**Complaint - Camera Image of Reversing Camera is Blurred, Water Stains on the Camera Lens: Observe Specified Procedure (19/21)**

Model Line: **Taycan (Y1A)**

Equipment: **ParkAssist incl. Surround View (M-no. KA6)**

*Reversing camera*

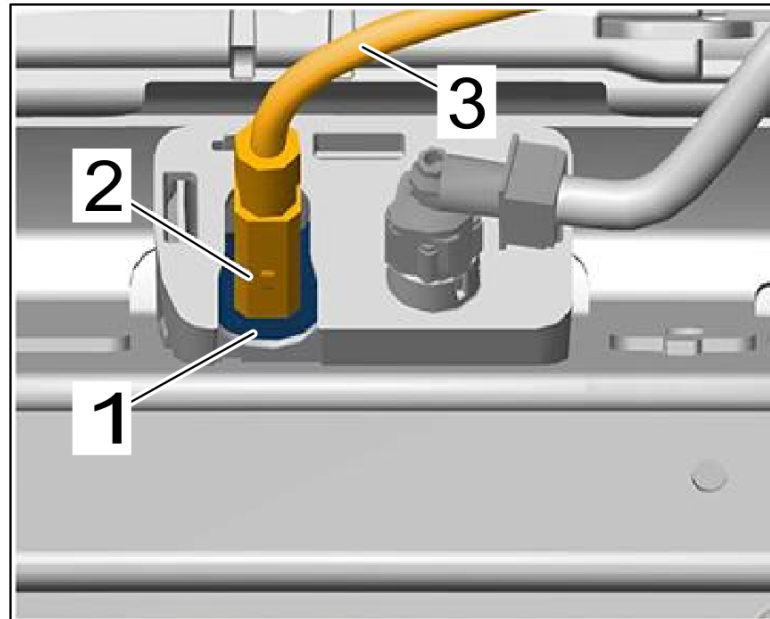
Information: The customer complains about a blurred camera image or water stains on the camera image of the reversing camera. This may be caused by water seeping in at the **electric plug connection** for the reversing camera, resulting in soiling or damage.

A new type of rear wire harness with an improved seal at the plug connection for the reversing camera is available.

Rear wire harnesses with the **part number index G or H** (Part Nos.: 9J1971104**G**, 9J1971104**H**) already have the improved seal in the plug connection for the reversing camera. If the rear wire harness has a **part number index A-F**, it must also be replaced.

Action required: In the event of a complaint, replace the reversing camera and, depending on the type of wire harness, also replace the rear wire harness if necessary.

- 2 Check wire harness and replace it if necessary.
  - If the part number index of the rear wire harness is **G or H**: The new type of wire harness is already installed. Continue with ⇒ *Technical Information '914319 Concluding work'*.
  - If the part number index of the rear wire harness is **A to F**: Replace wire harness, see ⇒ *Workshop Manual '972519 Removing and installing rear wire harness'*.
